Permit No: 0210240

Nature of Work: REMOVE EXIST. ROOFING, INSTALL NEW LIGHT WEIGHT TILE 16 SQ

RE: Re-roof at the Residence at 7682 Abaline St, Sacramento, CA
This inspection and letter is our Job # 02-1022.

RE: Re-roof at the Residence at 7682 Abaline St, Sacramento, CA
This inspection and revised letter is our Job # 02-1022.

SKETCH - ROOF PLAN
~SCALE - 1" = 10'

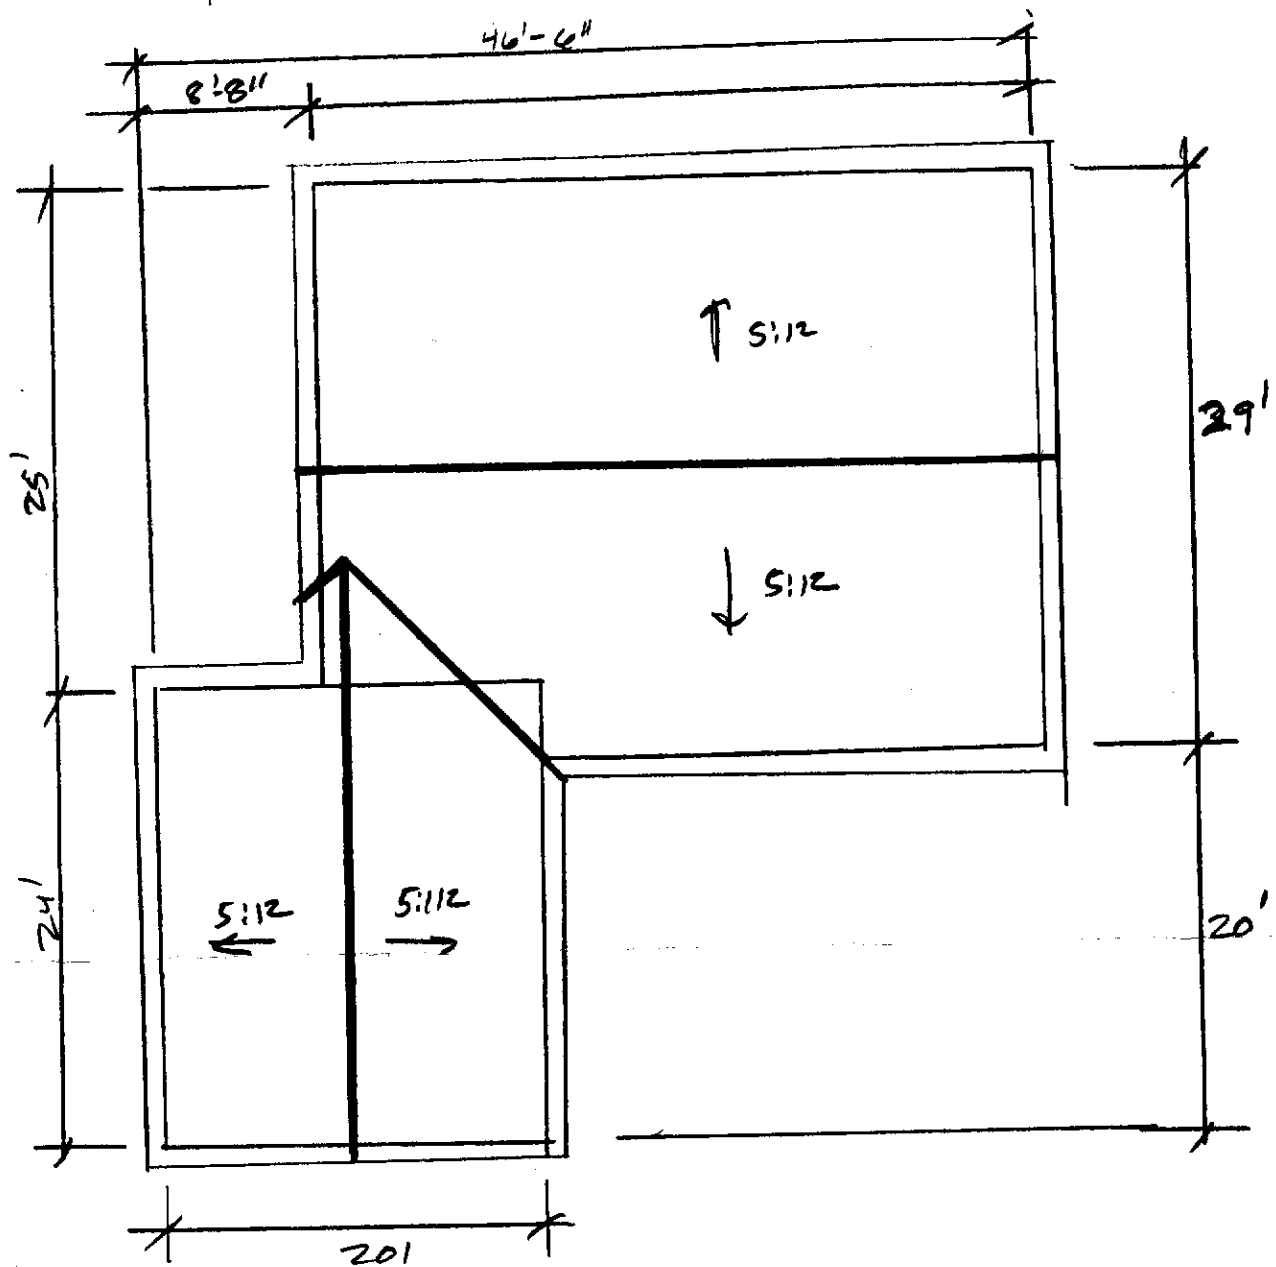
Per your request, I performed a visual inspection of existing roof framing at the aforementioned residence. The purpose was to determine if the existing roof framing is acceptable to support a light weight tile (6 psf max installed weight) instead of the existing wood shake. The existing roof framing on the house consisted of Pre-Fab Trusses spaced at 24" c.c., with the 2x4 top chord's spanning 7'-3" max. The existing roof framing was in good condition with no existing excessive deflection -except as noted below.

The residence is a 1-story building with the standard living areas and garage. Attachment #1 shows a sketch of the roof plan with approximate dimensions.

Thus, it is my professional opinion that it is acceptable if all layers of the existing roof coverings be removed, plywood (or OSB) is placed or the skip sheathing filled in with 1x material, new 30# felt placed, and then re-roofed with a light weight tile, with an installed weight of 6 psf or less, installing it per the manufactures recommendations.
